CAMWEST
CYCLISTS' ACTION MOVEMENT

M4 Bridge Pedestrian Ramps Upgrade Feedback

Thank you for the opportunity to comment on the plans for the M4 Bridge Pedestrian Ramps Upgrade at the Nepean River, Penrith (*The Plan*).^[1]

NE Ramp, with No Pedestrian Access sign and one couple walking against the sign.

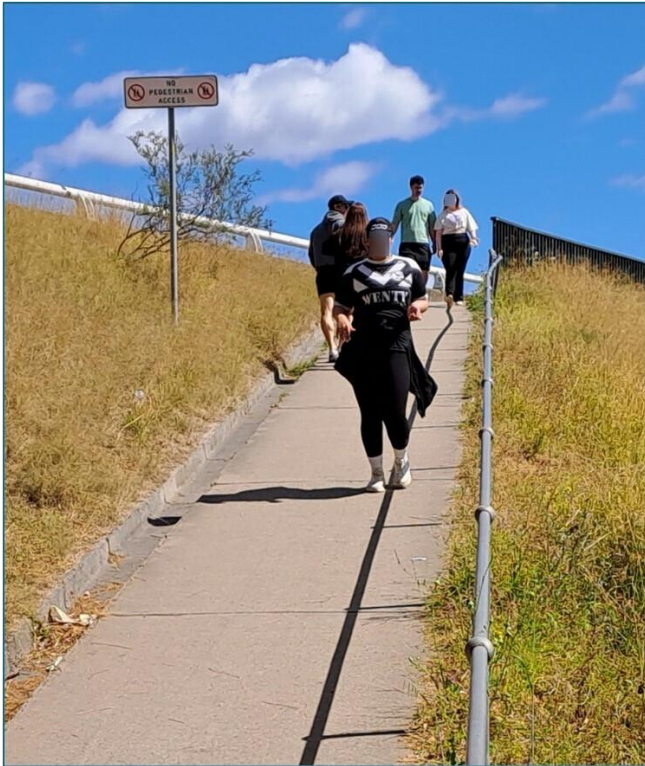
The current ramps are around 1.8m wide, although weeds have encroached on a couple of them effectively narrowing their widths a little. There are currently 'No Pedestrian Access' signs against the recommended flow of movement. We feel the current signage is confusing. Why say 'No Pedestrian Access' when there are clearly pedestrians coming from the opposite direction? We observed most people that were walking on the southern side of the M4 in the 'recommended' direction, but some groups of people walking against the flow on the northern side.

Northern bridge, with two couples passing.

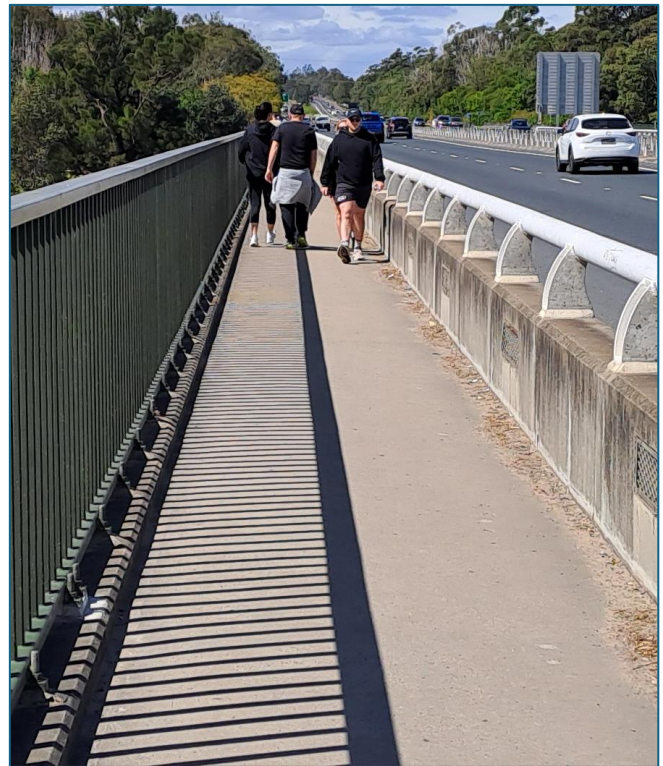
The two bridges alongside the M4 carriageways are around 1.75m wide.
